**Addendum No. 1**  
**January 12, 2024**

Project: **Lennox High School Addition**  
Lennox, South Dakota  
Architecture Incorporated Project No.: 2982

4.10-G

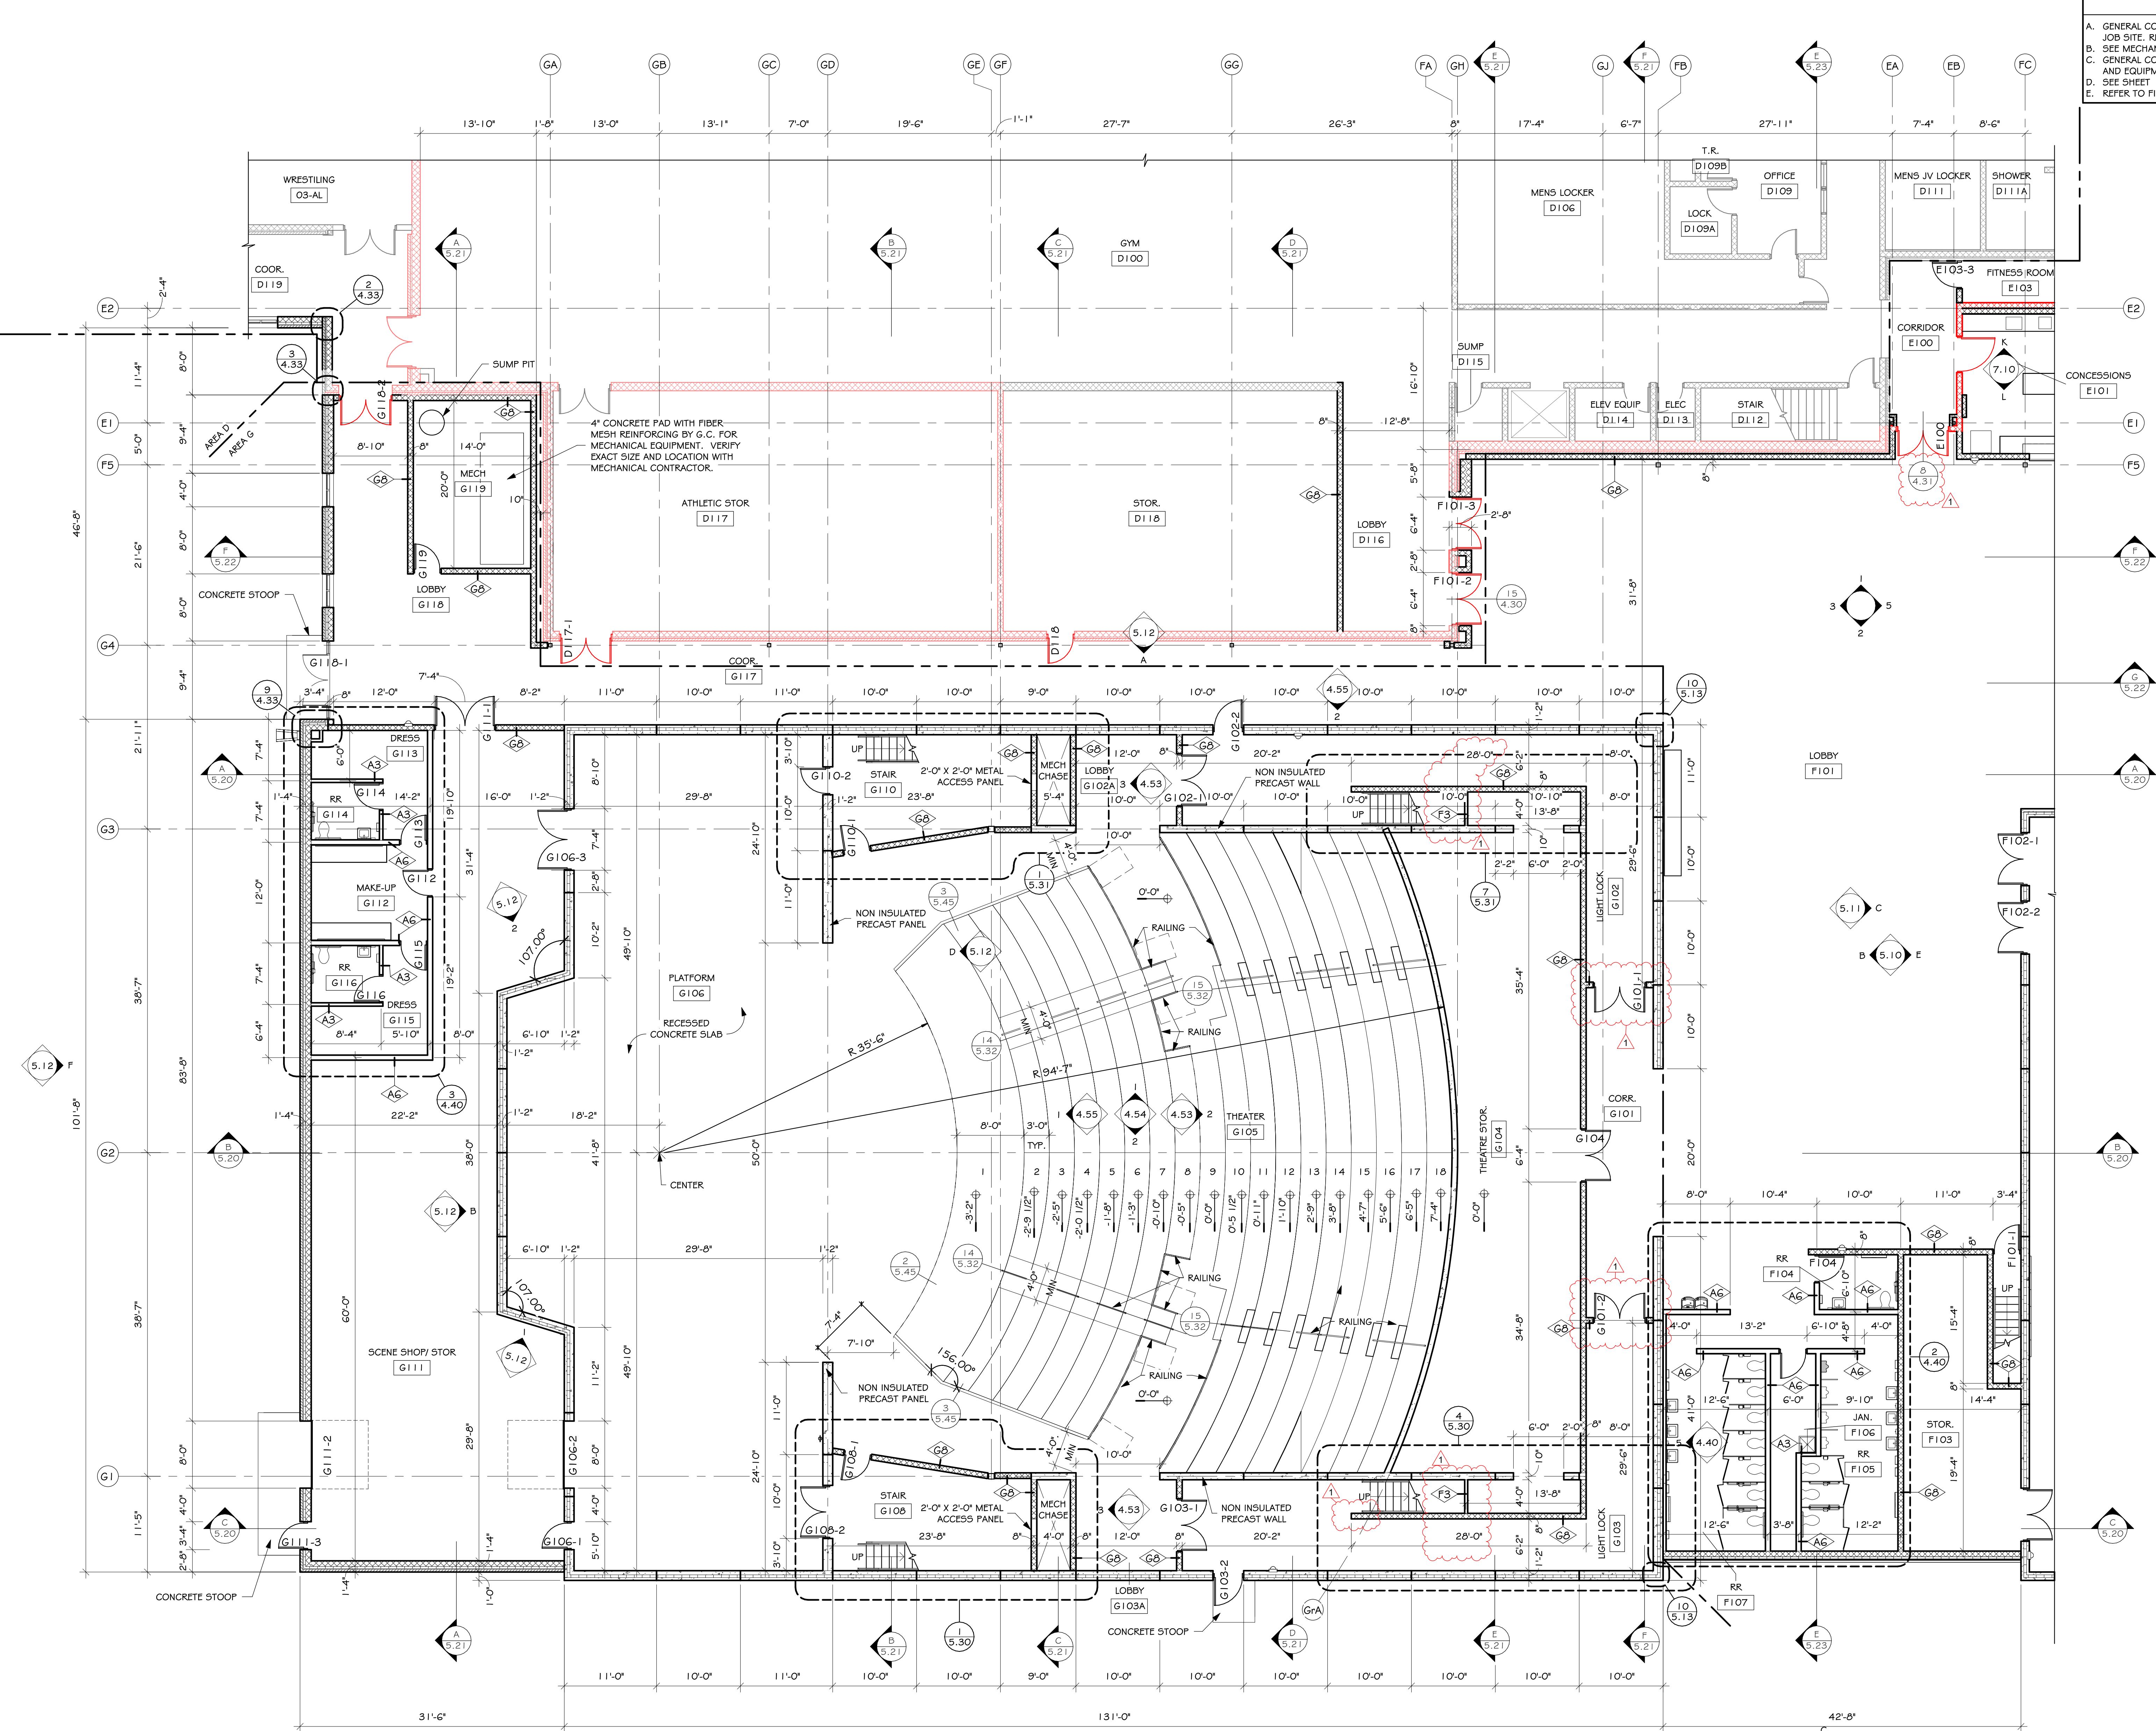
- i) See Sheet 4.10-F for gymnasium equipment and floor plan notes.
- 10) SHEET 4.10-G – FLOOR PLAN – AREA G
- a) Add a 3 5/8" stud wall with 5/8" gypsum board on one side underneath STAIR G102B and STAIR G103-B as shown per *revised* drawing Sheet 4.10-G, dated 1.11.2024, attached to the end this addendum.

- c) The jambs and exposed (west) faces of the insulated precast wall panels that are visible in Corridor G101 shall be made with colored concrete and match Finish 2.

- d) Reference *revised* drawing Sheet 4.10-G, dated 1.11.2024, attached to the end this addendum for other minor changes.
- 11) SHEET 4.11-F-A – MEZZANINE PLAN – AREA F ADD ALTERNATE #1

4.21-G

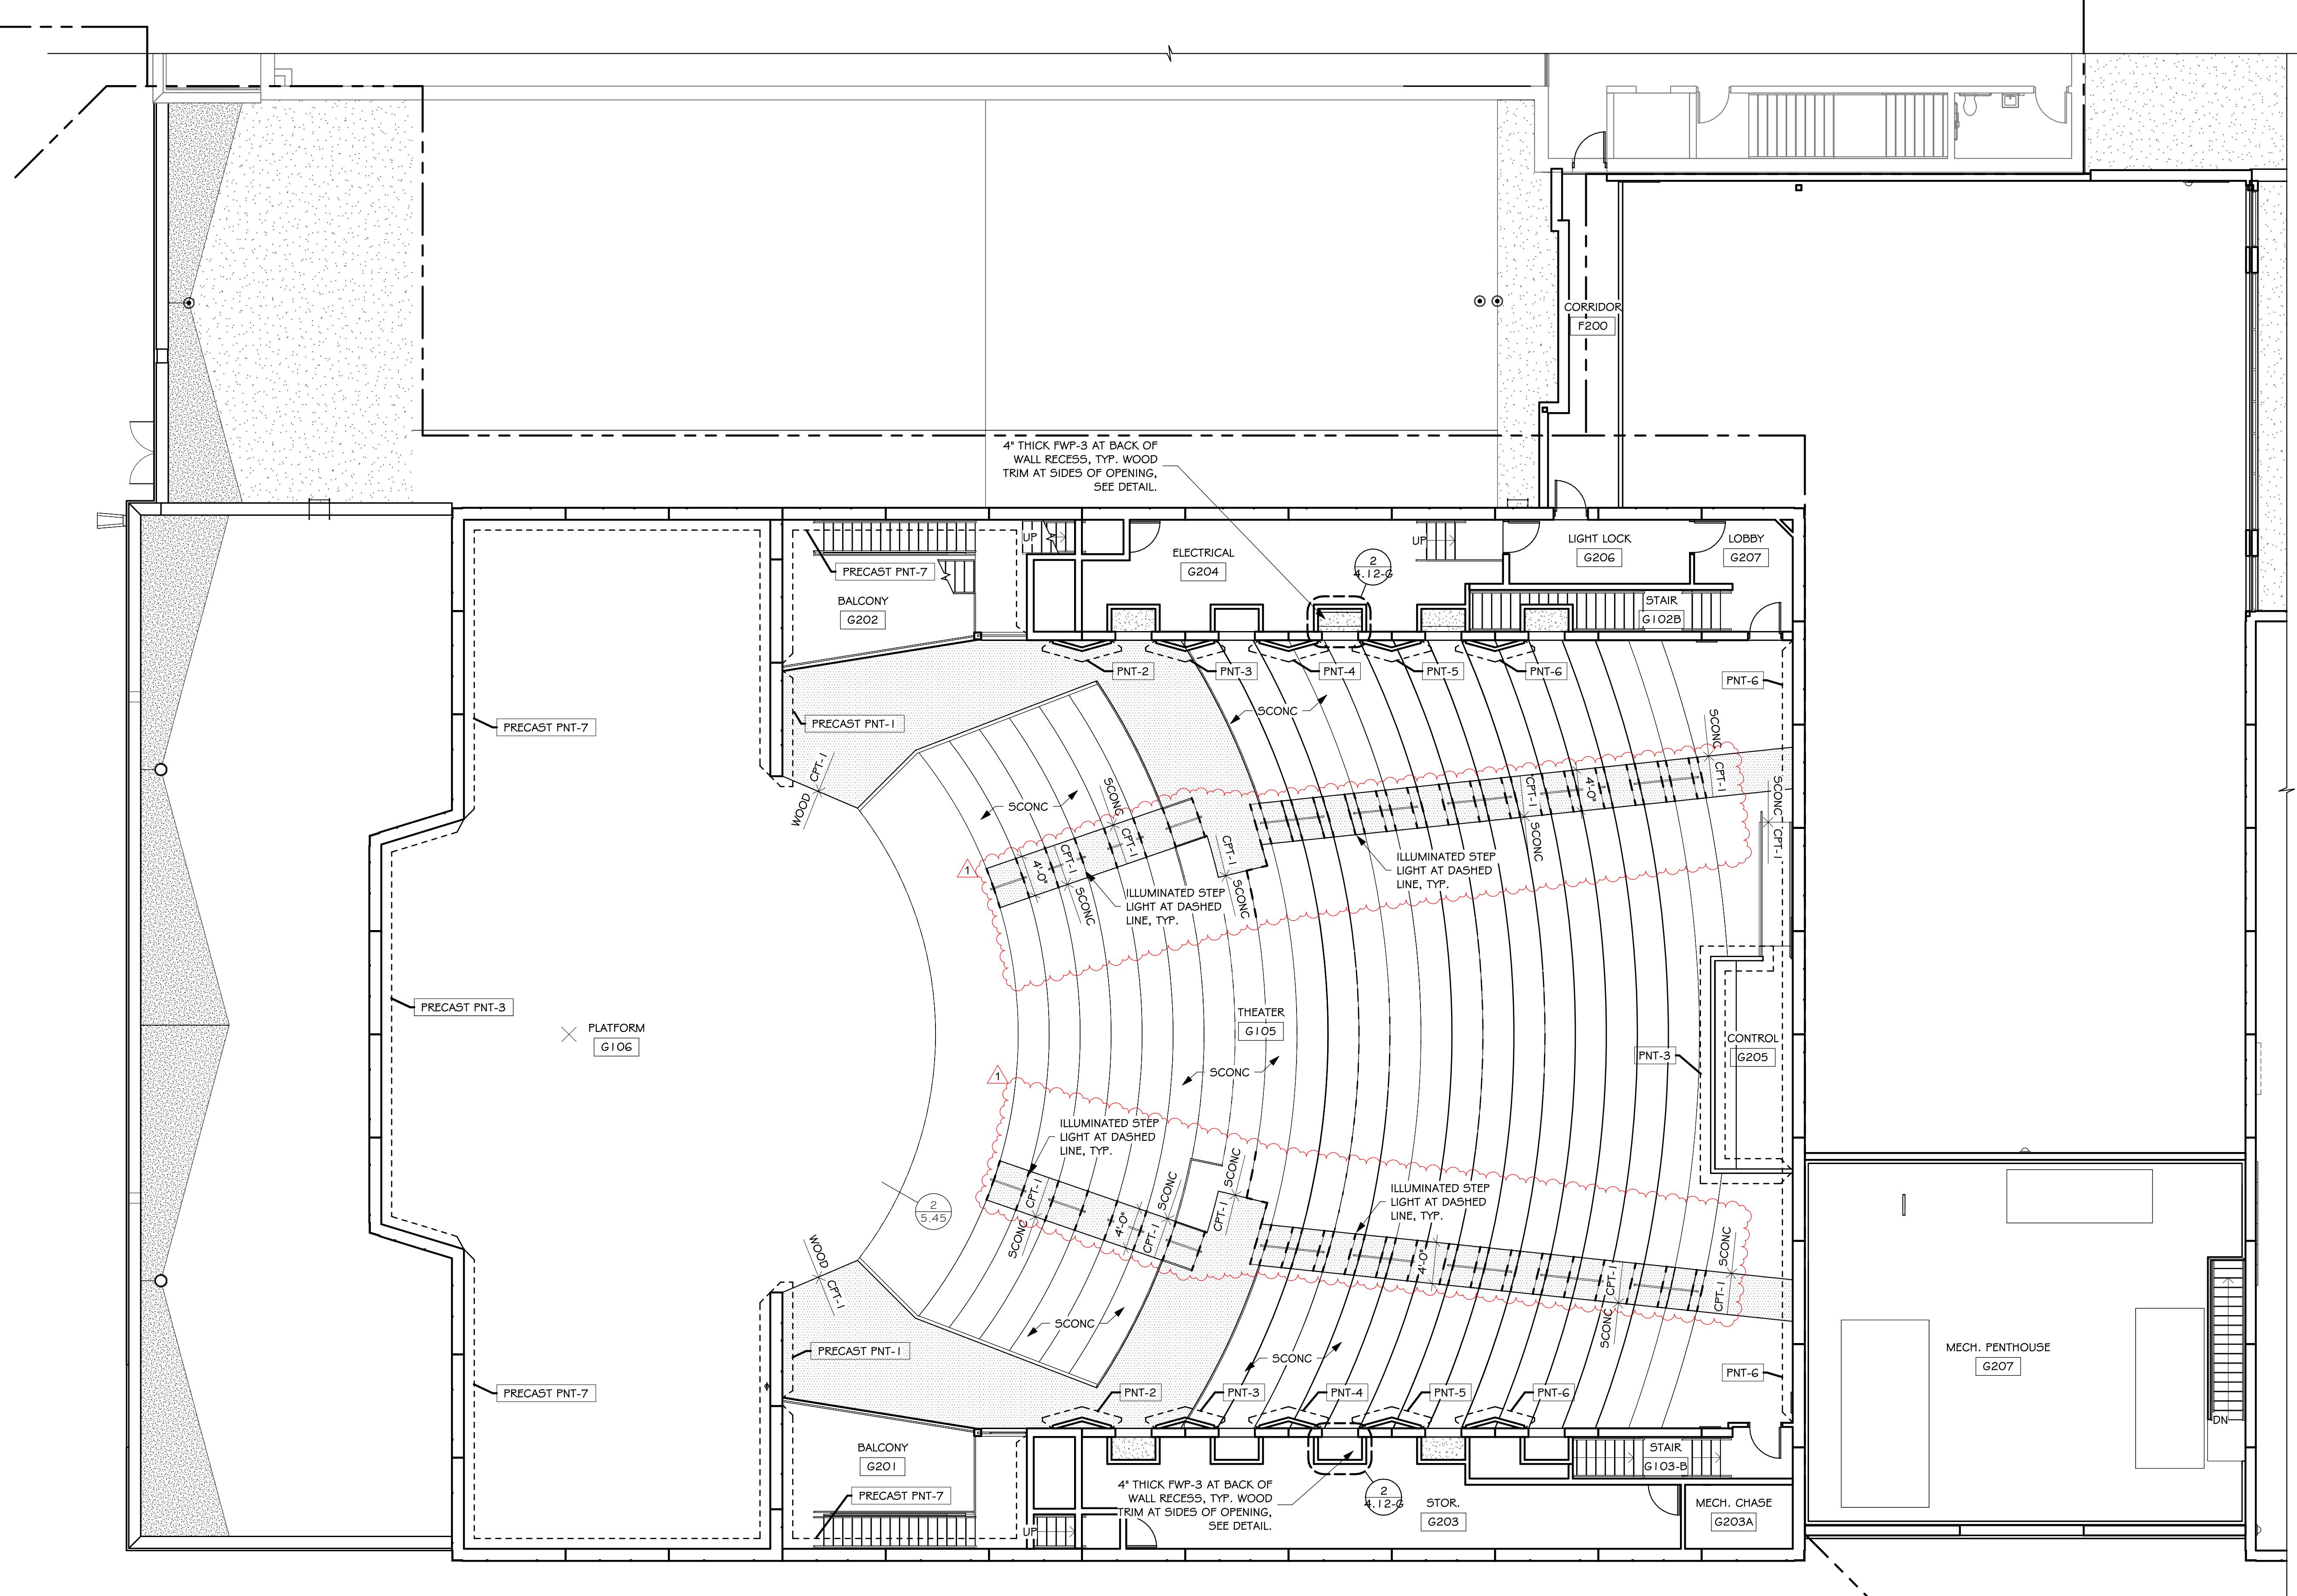
- 13) SHEET 4.21-G – FINISH PLAN – MEZZANINE – AREA G
- a) Reference *revised* Sheet 4.21-G, dated 1.11.2024, for illuminated step light notes at Theater step aisles.

10  
5.31

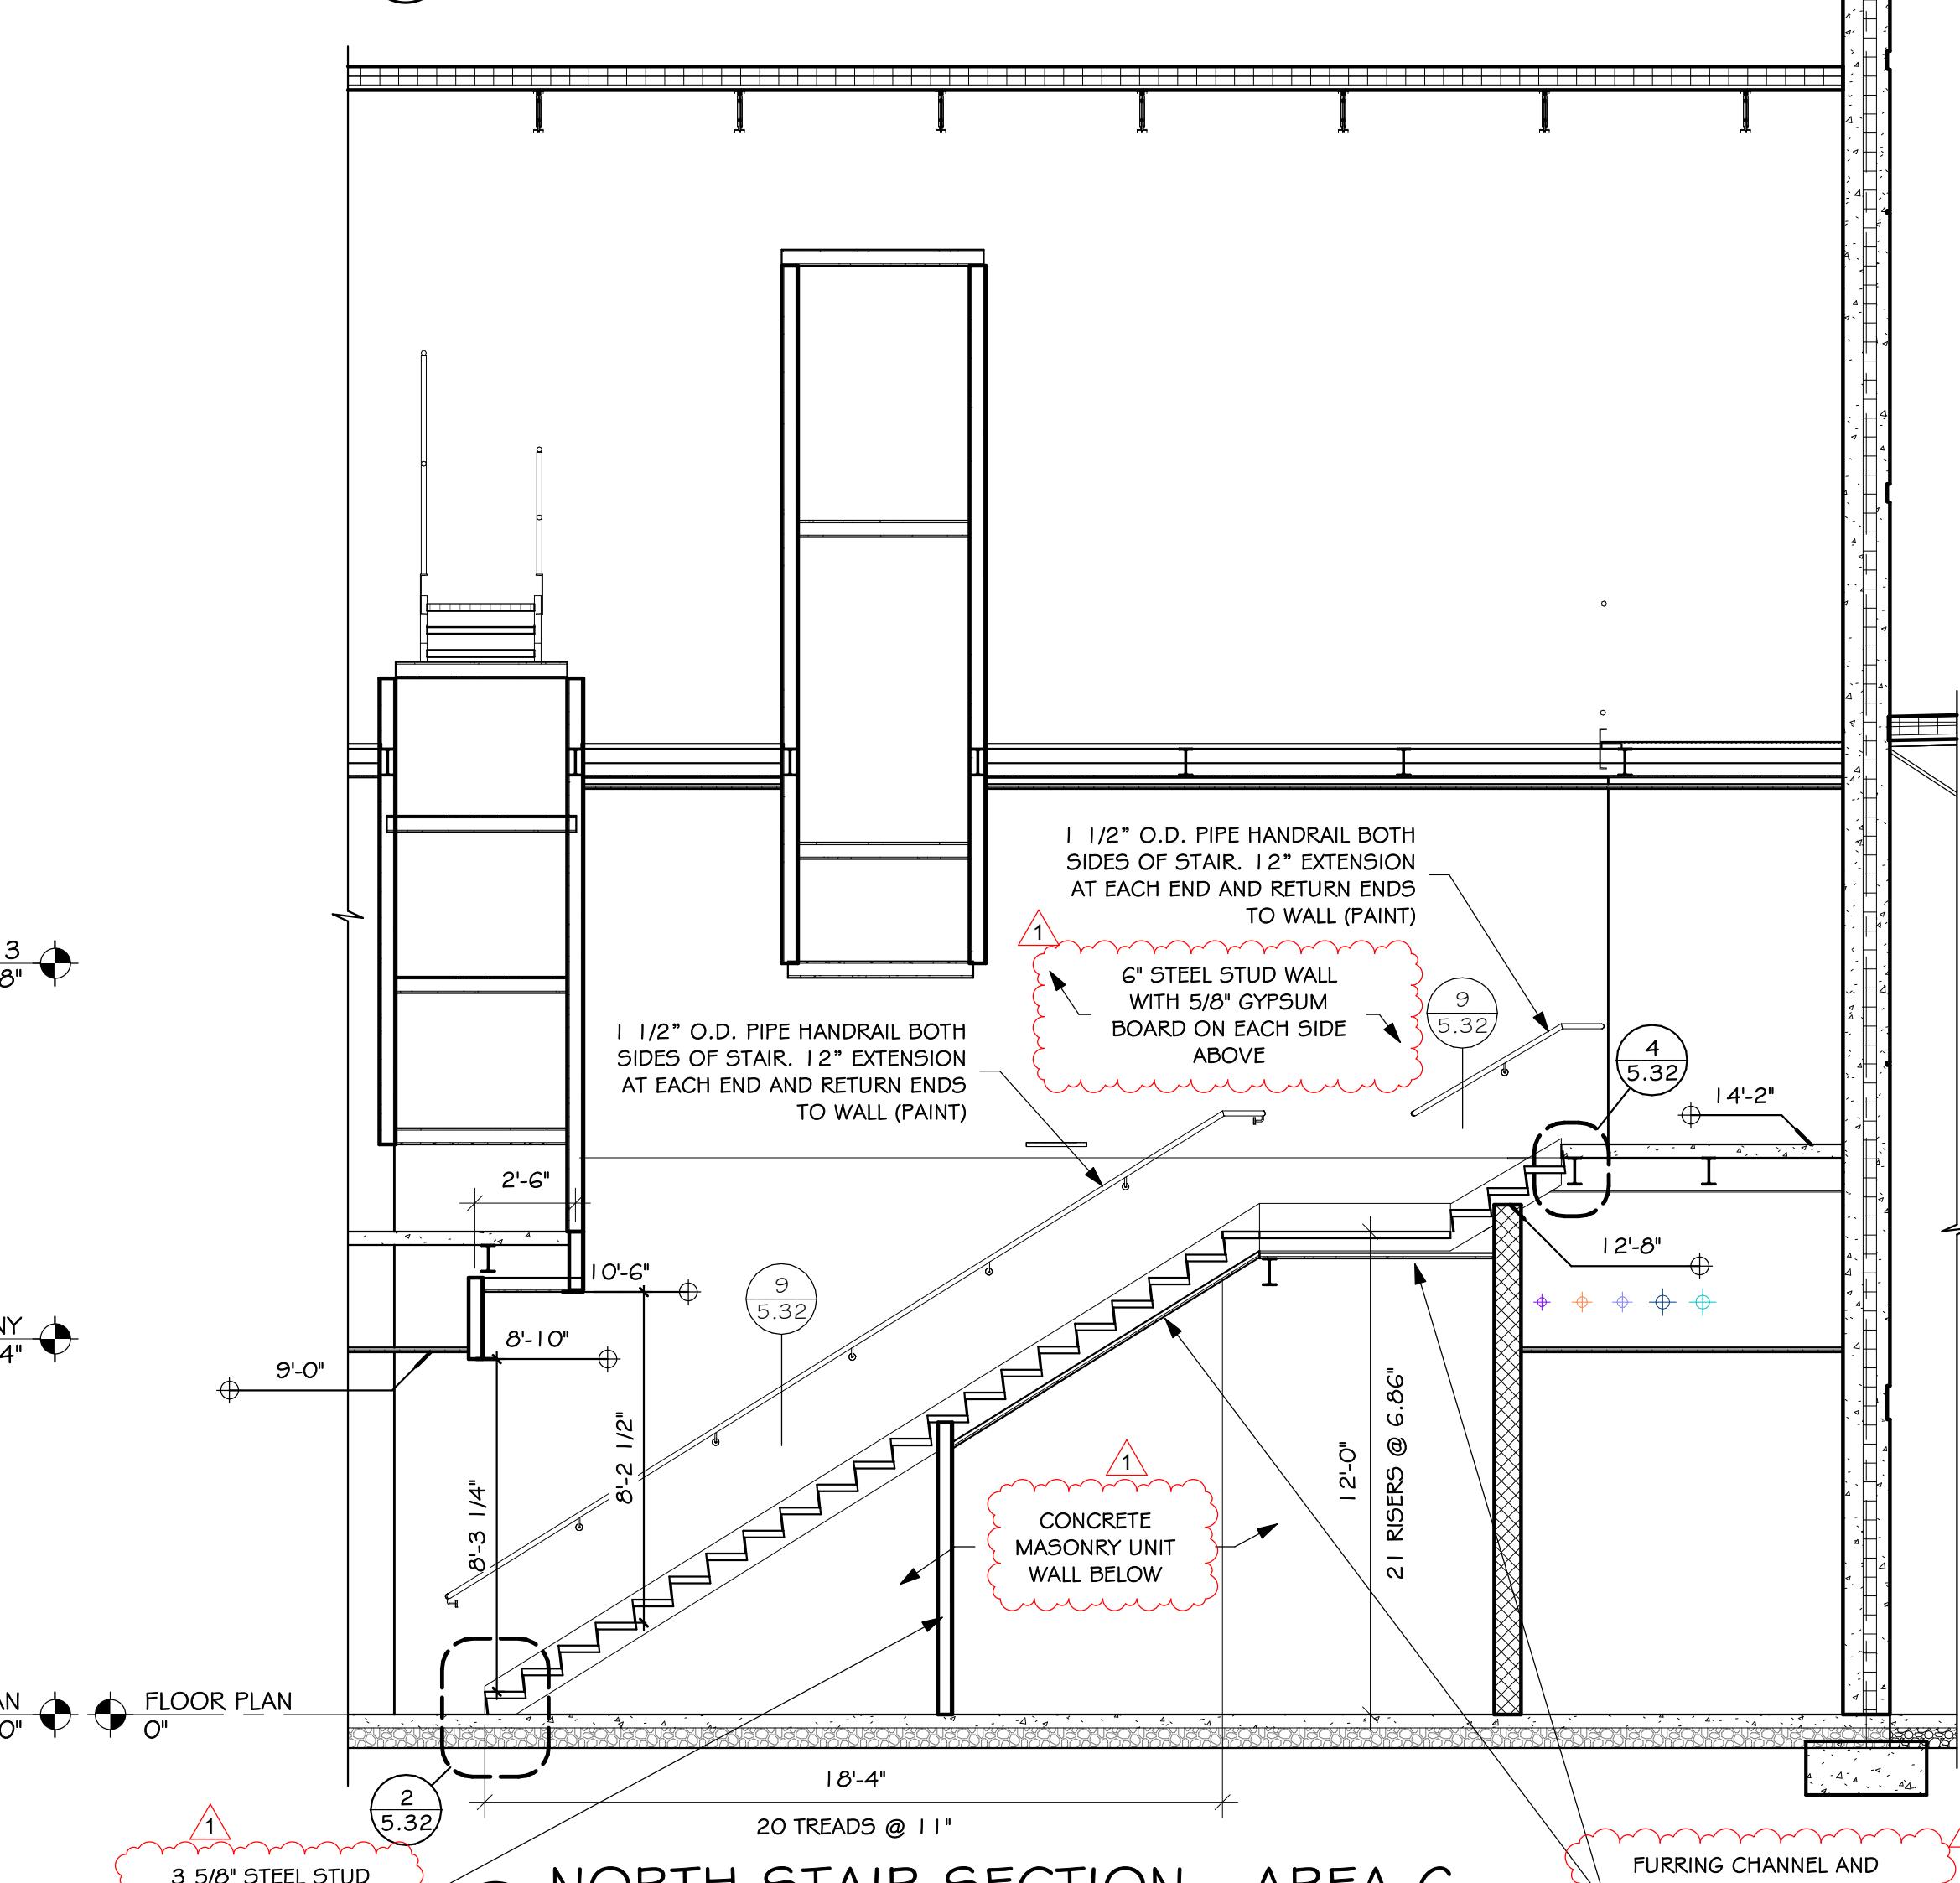
- i) The north concrete masonry wall of STAIR G102-B shall extend to the underside of floor deck; wall above shall be 6" steel stud with 5/8" gypsum board on each side as indicated in the revised North stair section 10/5.31.

- ii) Add furring channel and 5/8" gypsum board to the underside of the stair as shown in revised north stair section 10/5.31.
    - iii) Add 3 5/8" steel stud wall with 5/8" gypsum board on one side underneath the stair as shown in revised north stair section 10/5.31.
